CLIENT: ENER TEKNOLOJI

PROJECT :
AIR COOLER FOR
Toase-ehe Park Sanati Gohar Ofogh Petrochemical Co.
General Arrangement Drawing
1158-A01-1000-00

DWG. NO. EI027-DMF-VD-ME-DWG-003
SCALE : N.T.S. SIZE : A1 REV. : R4

FRONT VIEW
CL. A,C

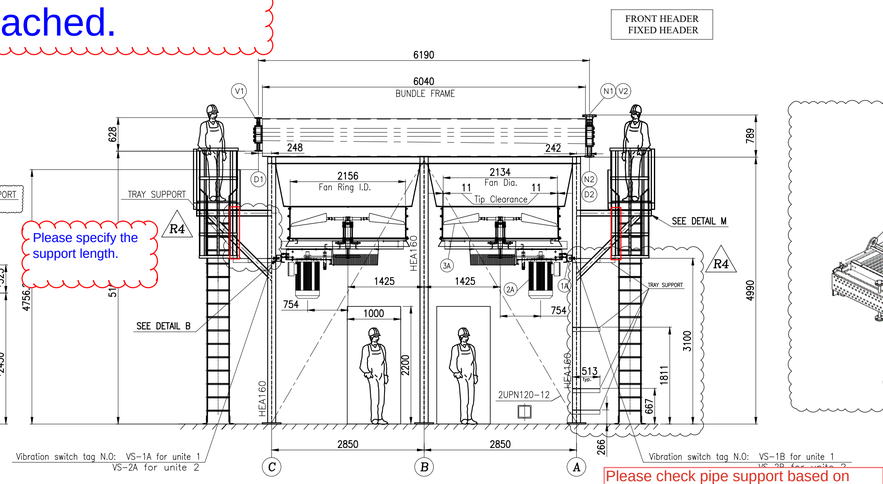
Please specify the support length.

Please check pipe support based on updated drawings

TOP VIEW

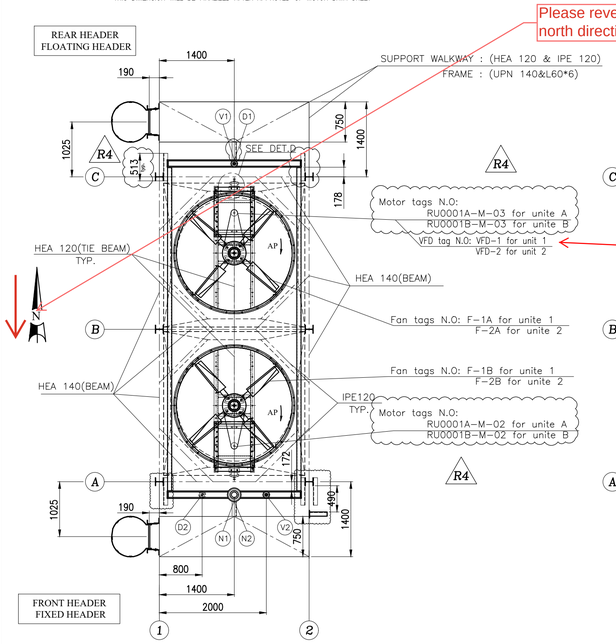
Please reverse north direction

Tag No for vibration switch:
RU0001A-01A for unite A
RU0001A-01B for unite A
RU0001B-01A for unite B
RU0001B-01B for unite B

Tag No for Fan
RU0001A-F-02 for unite A
RU0001A-F-03 for unite A
RU0001B-F-02 for unite B
RU0001B-F-03 for unite B

Tag No for VFD:
RU0001A-VFD-01 for unite A
RU0001B-VFD-01 for unite B

please specify the distance of the supports from column center.

FRONT VIEW
CL. B

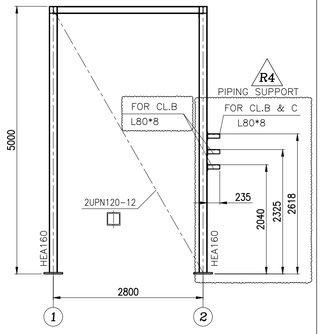
Please put the dimension for height of support.
